No.: 14 TS-4
February 28, 2014

SUBJECT: **Valve and Liner Installation Tool Issue**

d580153

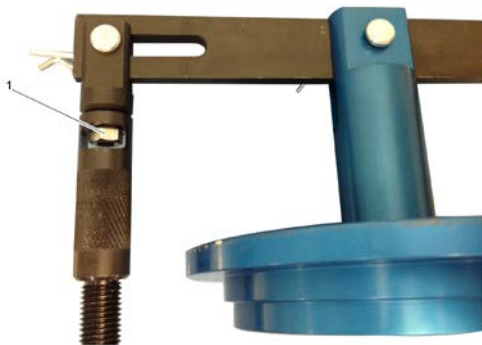
Valve and liner installation tool part numbers J-47406 and J-47407 have lock nuts on the swivel lever retainers that could loosen unexpectedly. This can potentially cause injury if the nut (1) falls off the threads during use.

Prevent this issue by adding a thread-locking compound (Loctite or equivalent) to the nut threads before the next use. Use care not to tighten the nut to prevent the swivel from rotating during repairs.

d580154

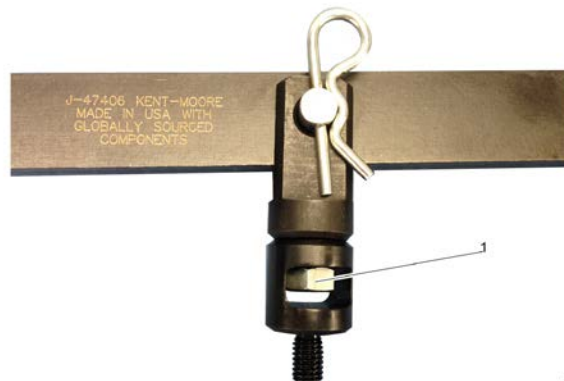
Note the repair locations in the pictures below:
